MIDVALE PLAZA NEIGHBORHOOD STEERING COMMITTEE

Midvale Plaza Redevelopment Project Neighborhoods' Steering Committee Modification Proposal & Rationale

The Westmorland/Midvale Heights Neighborhood Steering Committee Modification Proposal

HEIGHT OF
PROPOSED
RE-DEVELOPMENT
MIDDALE PLAZA
4-STORIES

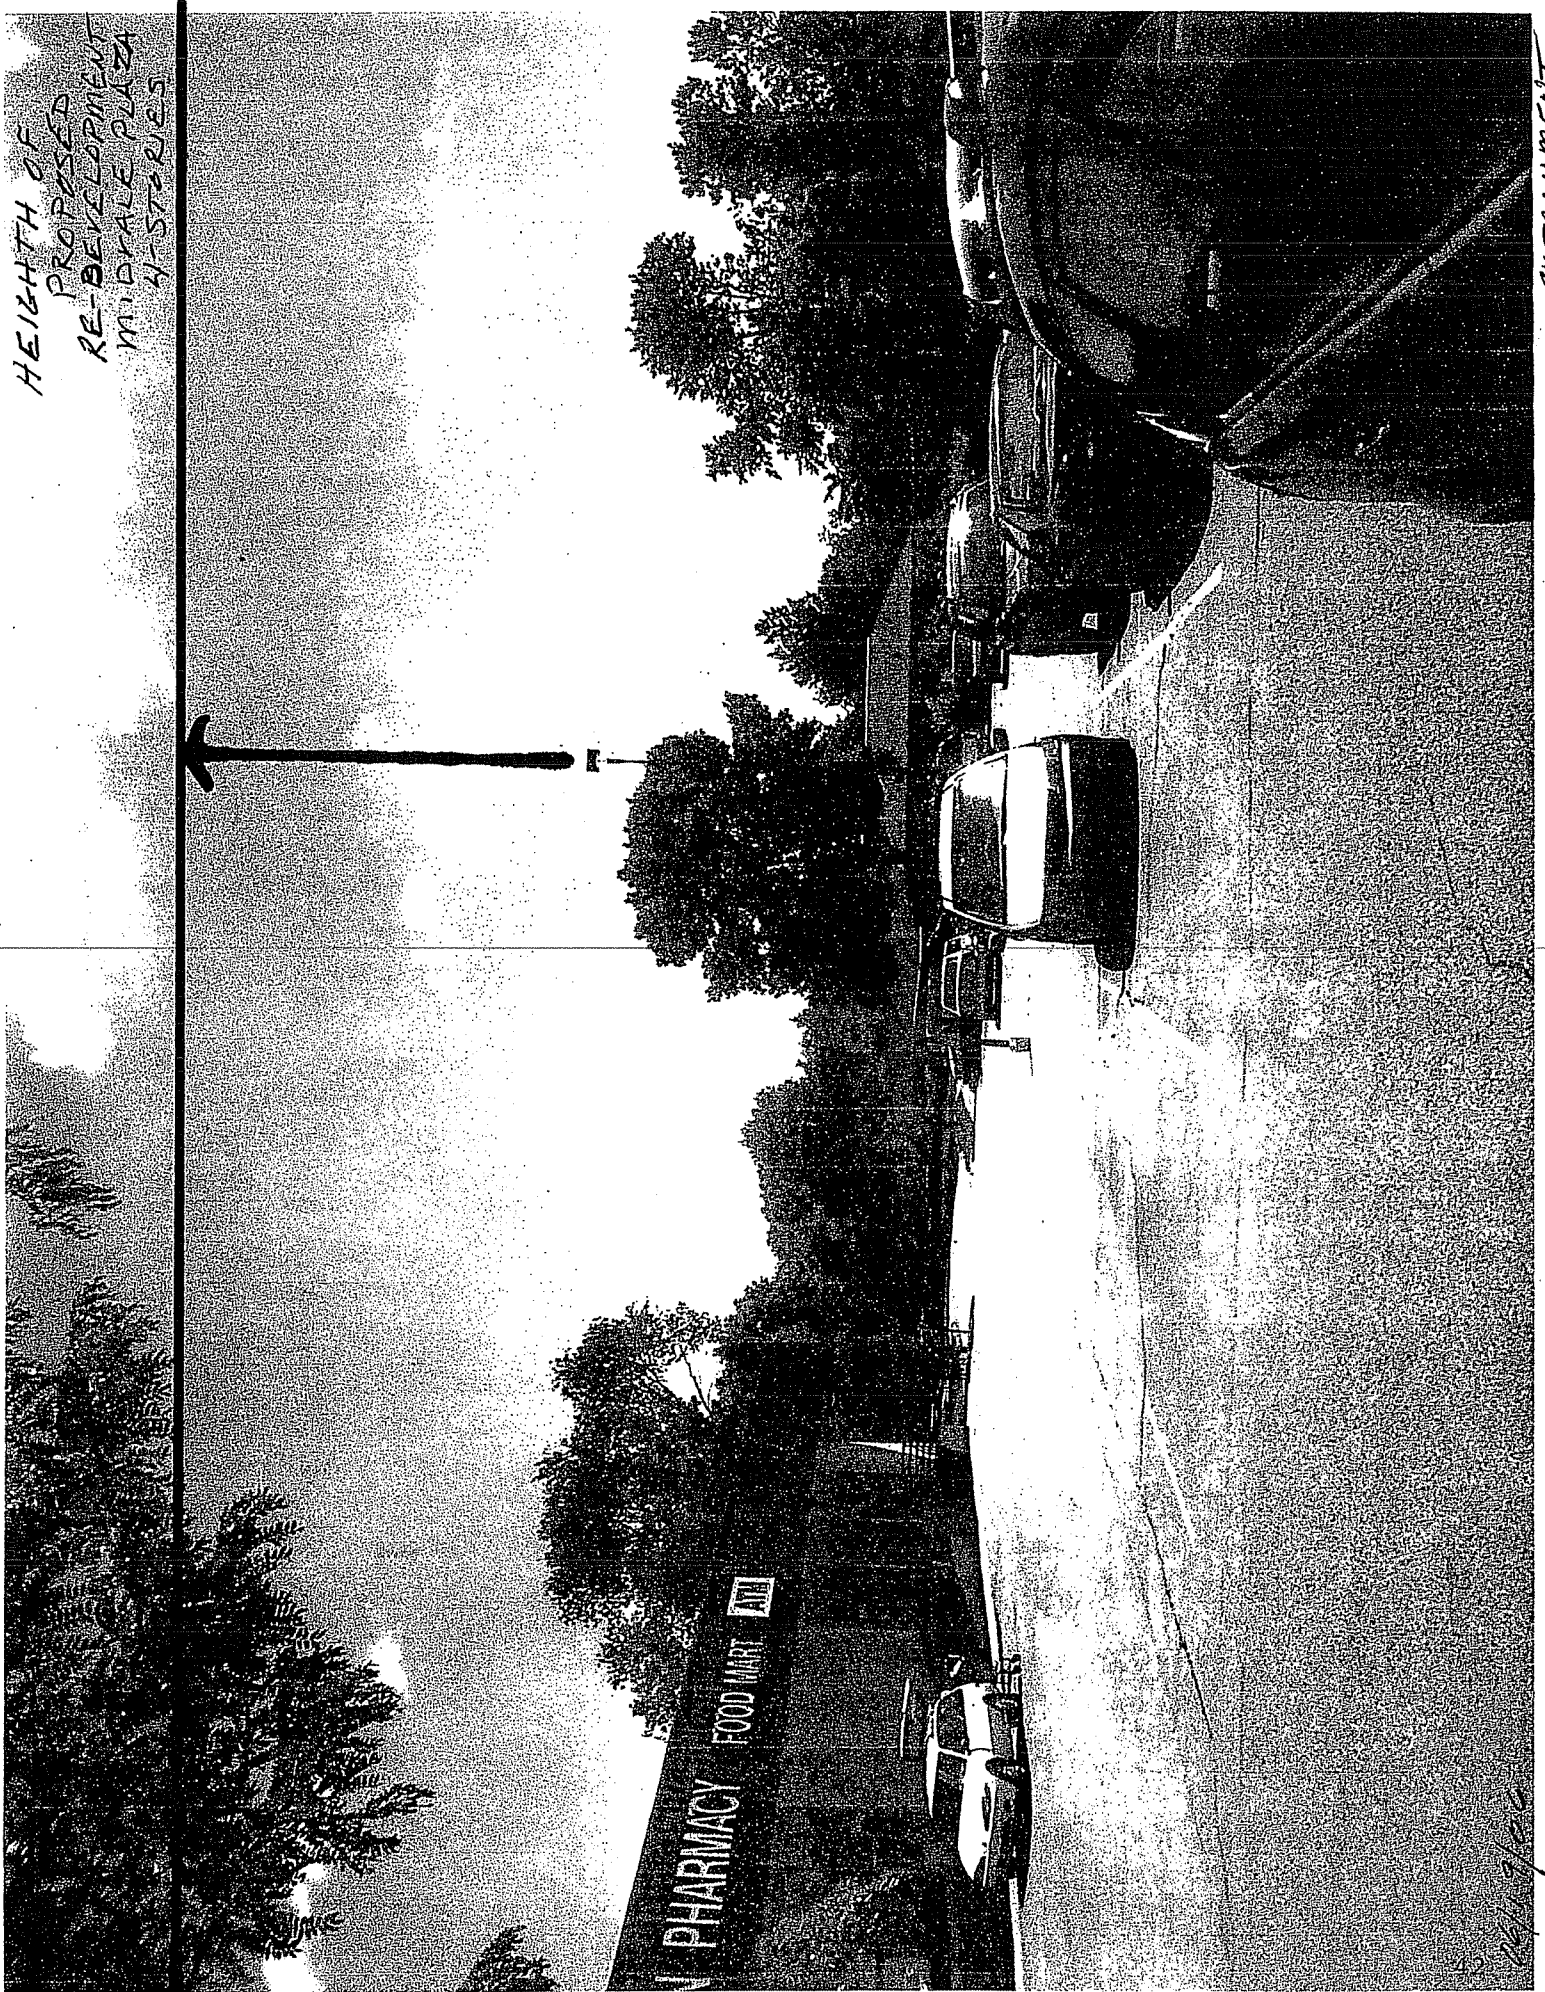
Here (see attachments) are the comparative illustrations of scale that demonstrate the significant negative impact of high density on this site. The comparisons show the relative sizes of the proposed 4-stories, the existing single-story plaza, an existing street light pole, and a typical ranch house.

We are supportive of "infill" and NOT "overfill" (40 units per acre) as is currently proposed. The Comprehensive Plan provides differentiation between higher and lower density neighborhood areas. Now, the Plan Commission and the City Council can continue its leadership by applying the contextual guidelines of the Comp Plan with
